**Report by the Mining & Petroleum Gateway Panel
to accompany a Conditional Gateway Certificate
for the Maxwell Coal Project**

December 2018

Figure 4. Sample site locations for the 2015 soil survey within the GCAA (SLR, 2015).

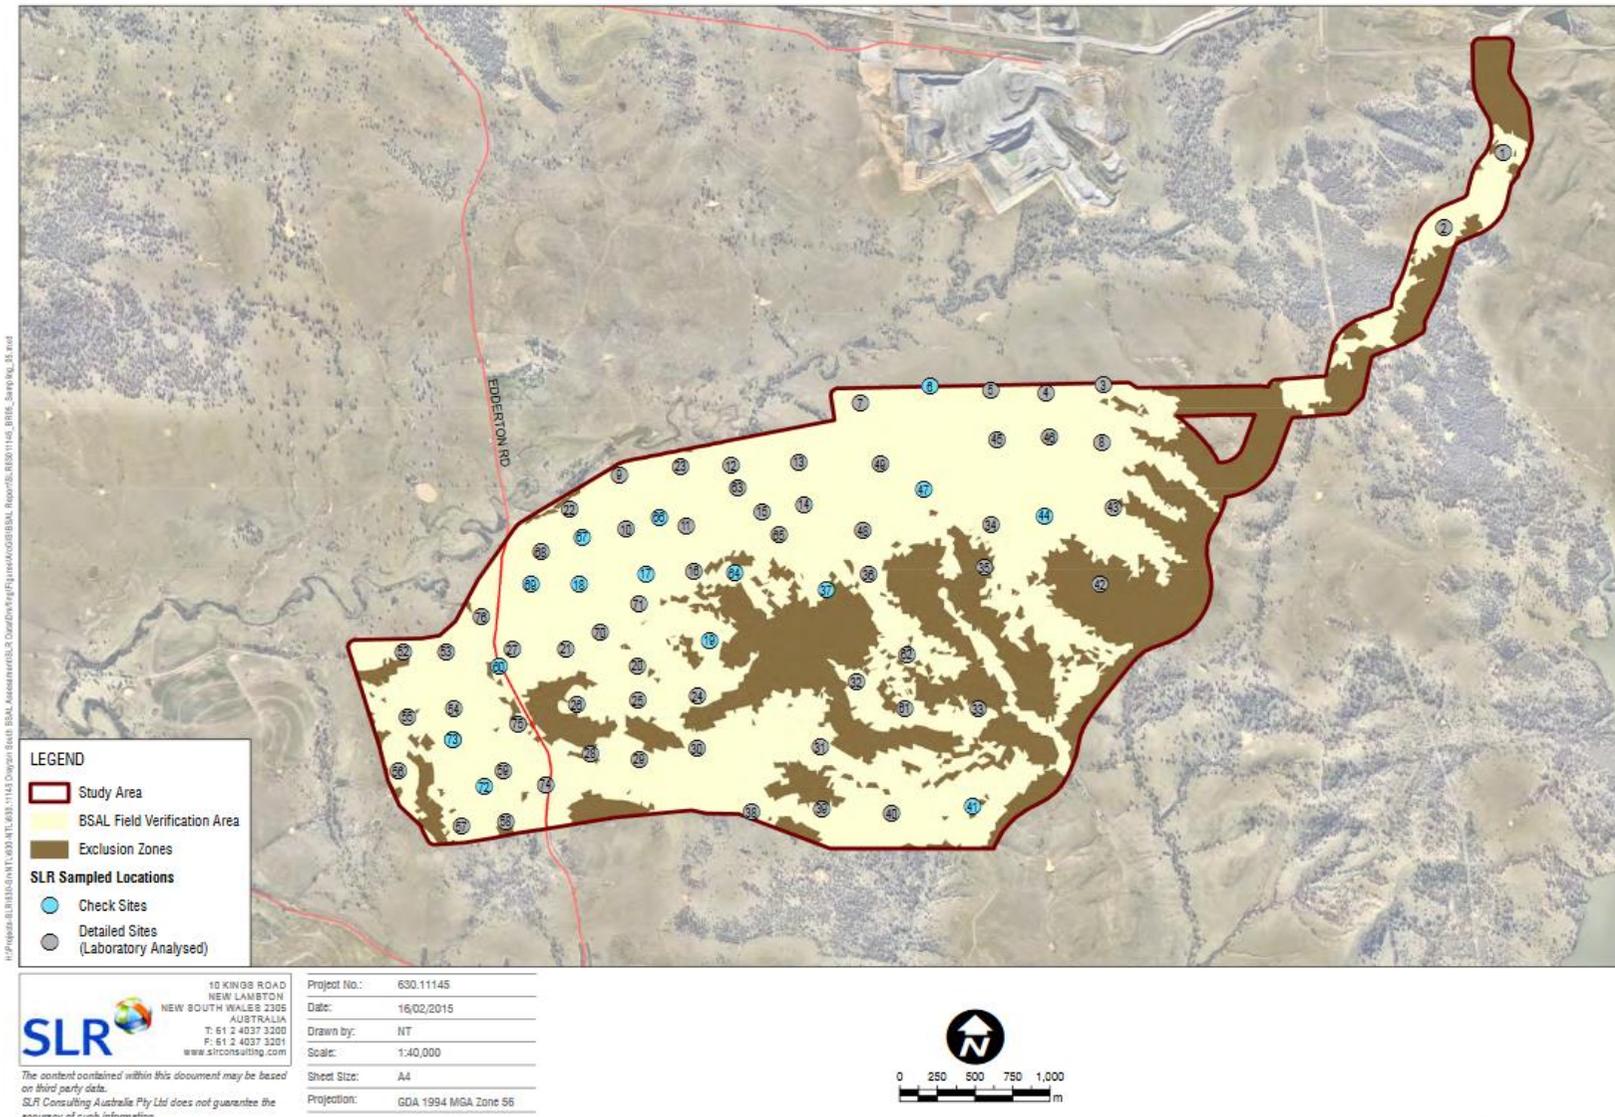
The detailed soil survey and assessment for this project used data gathered in two survey operations, one undertaken in 2015 and reported in SLR (2015) and one undertaken in 2018 and reported in SLR (2018). Figure 4 shows the sample site locations and numbers for the 2015 survey. The SLR (2018) report is also a document that aims to coalesce the findings of the two soil surveys that together cover the GCAA for this Maxwell Coal Project application. The Panel notes that there are discrepancies between the two survey documents in the total GCAA application area (-13 ha), the exclusion area (+97 ha) and the final detailed soil survey area (-110 ha) reported in SLR (2018) as representing the respective assessment areas in SLR (2015). The panel is assuming this occurrence may be due to refinements in border and elevation mapping techniques since the 2015 survey, however it is recommended that this issue be addressed/rectified in future documentation. The GCAA, exclusion and final survey areas quoted for the two surveys in SLR (2018) will be applied herein.

The Panel does however wish to note that in the southwestern area of the GCAA that was examined in the new survey (SLR, 2018), close to the identified BSAL (SLR,2015) and the potential BSAL (DP&I,

2012), the Applicant has taken only 6 detailed sample sites plus 3 check sites in an area that, with minimal access by the Panel to spatial data sets, is estimated at greater than 300ha. This results in a detailed survey resolution of 1 detailed site : 50ha. The Panel suggests that the sample density in this area of the GCAA is below that required to adequately determine BSAL condition in this case.
